**BEAUFORT–PORT ROYAL
METROPOLITAN PLANNING COMMISSION
AGENDA**

- V. **Review of Projects for the City of Beaufort:**
 - A. **Pointe Grande, MPC 22-01, Sketch Plan.** The applicant, Hillpointe, LLC, is requesting sketch plan approval of a 328-unit apartment complex on a 23.98 acre site, located at Burton Hill Road and Old Salem Road. The parcel is zoned T5-UC/RMX.

Metropolitan Planning Commission

From the Department of Community Development
July 18, 2022

328-UNIT CONCEPT PLAN

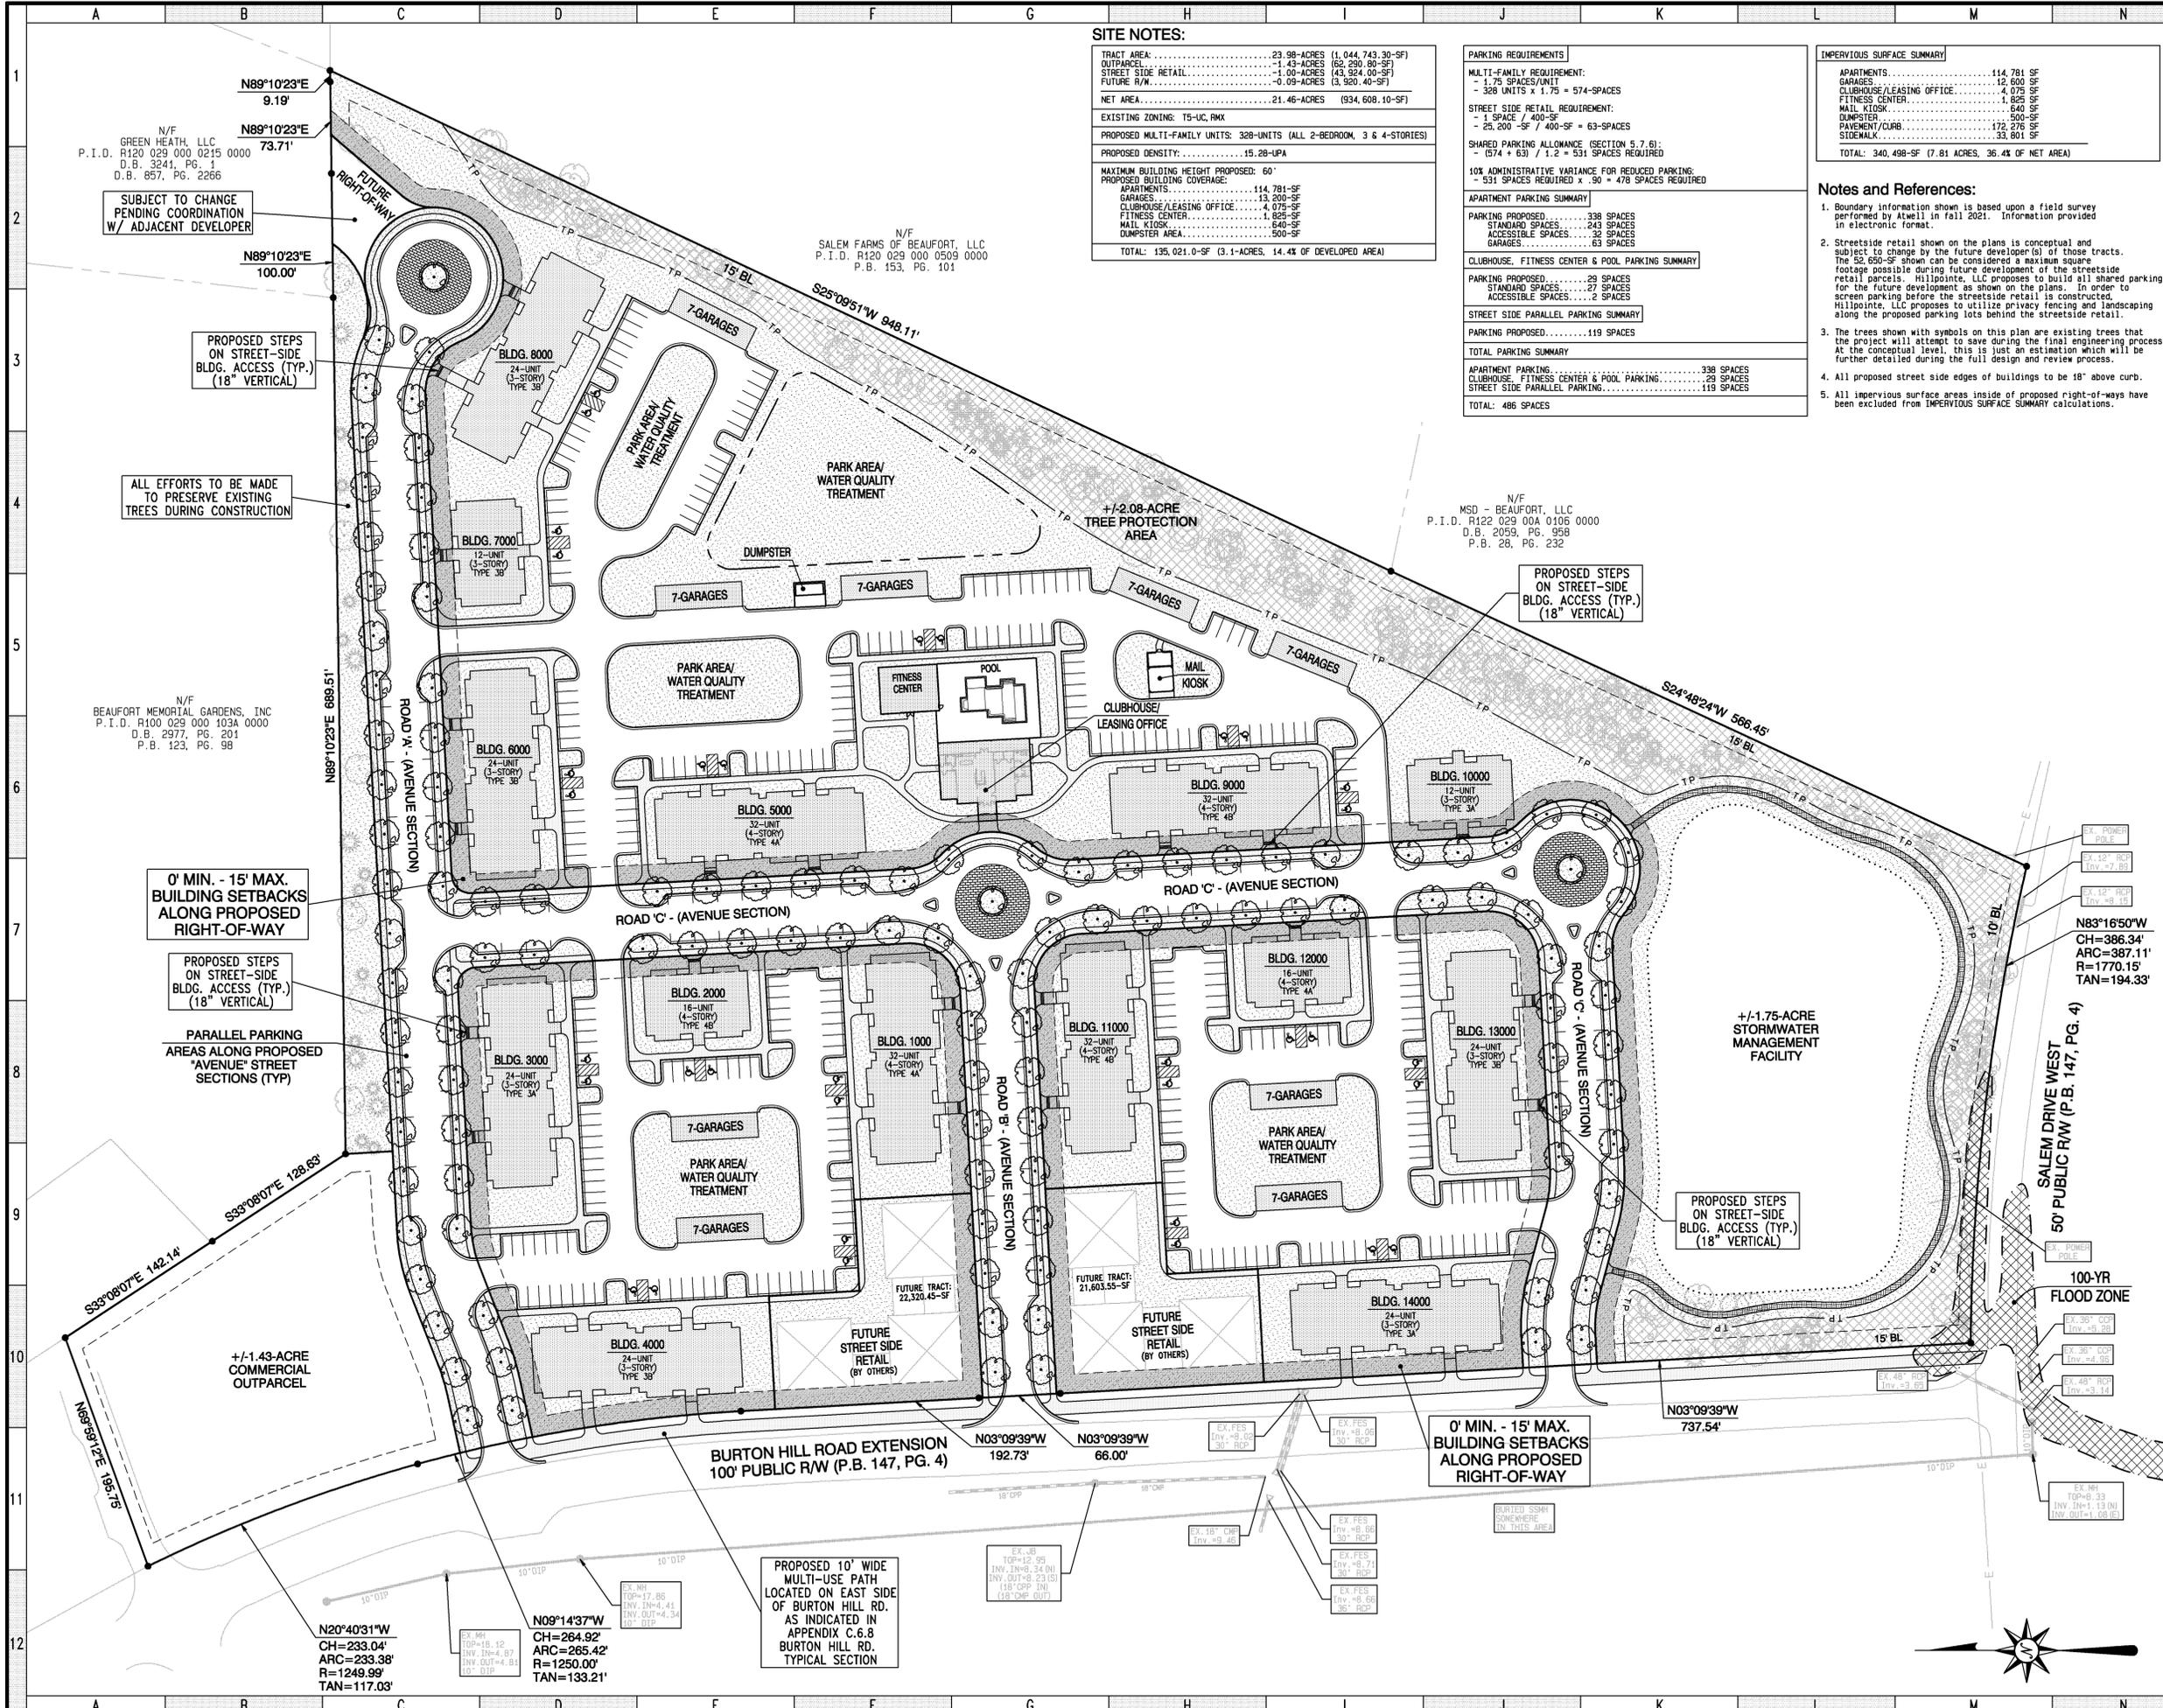
The property is zoned T5-UC/RMX. The applicant has relayed that they would like to follow the RMX standards. The maximum setback for T5-UC is 15', while the setback requirements for RMX range from 10' minimum to 60' maximum.

Currently, the sketch plan meets the minimum requirements for fronting buildings along streets, and there has been conscious effort to divide the multi-building site into smaller blocks. These elements will be further evaluated at the Design Review Board stage, but staff opines that the placement and orientation of the building relative to the streets meets the intent and standards of the code, specifically Section 2.5.1. Additionally, the placement of the leasing office at the terminus of the entryway is a feature that complies with the intent of the code in the opinion of staff.

During the redesign of the site, staff raised concerns regarding the concentration of parking at the entryway, potentially creating traffic hazards for cars reversing out of the diagonal spaces, or pedestrians. The revised entryway employs a traffic calming measure by the narrowing of the entryway, causing vehicles to enter the complex at a low speed, reducing the chance for an accident and the severity of a potential accident.

All roads proposed will meet the avenue street section of Appendix C. The applicant has provided a more detailed submission regarding the street sections from the past submittal, per the request of the MPC, showing sidewalk, planting strip and on-street parking. Staff recommends that either one dedicated bike lane be included in the street section, or that the applicant incorporate a shared R.O.W. with adequate pavement markings to enhance the multi-modal capabilities for these streets.

Currently there are three traffic circles proposed on the site. Staff has discussed this internally and agrees that the central traffic circle should be retained, but the other two traffic circles could be converted to a traditional intersection with stop signs as there is a concern that drivers not familiar with this traffic feature will speed through these intersections. Ultimately, staff will defer to the opinion of the MPC for their recommendation regarding this.

Compared to the previously submitted sketch plan, staff opines that a greater and functional level of pedestrian connections have been achieved throughout the site. The revised sketch plan features a pervious walking trail around the stormwater management facility at the southern end of the site. Staff recommends that textured and clearly delineated pedestrian pathways be included at all of the intersections proposed as an additional traffic calming measure, as well as furthering the goal of creating a more pedestrian scaled development.

Since the redesign, and as a result from the proposed administrative adjustment to the parking requirements, more space has been dedicated to park areas and open spaces. Currently there are several open spaces proposed in the middle of the various parking lots. Planning staff opines that these areas should be located closer to the building locations, so that building exits abut these green spaces and that they are not surrounded on all four sides by the parking area. Staff has provided an in the packet visually showing this edit.

The applicant has introduced a substantial tree protection zone along the east and south perimeter of the property. This zone conforms to the buffer requirements in the code. Additionally, the revision of the buffer area means that more trees will be preserved in this development, as well as adding a natural edge to the property.

To achieve this, staff will approve of an administrative adjustment to reduce the parking requirements by 10%. Further, the applicant's original parking layout was to adhere to the minimum standards by the City, not what the applicant needs to satisfy their own tenants. Lastly, the administrative adjustment allows more space within the development to be dedicated to the tree protection area, sidewalk connectivity, and open spaces for recreational use.
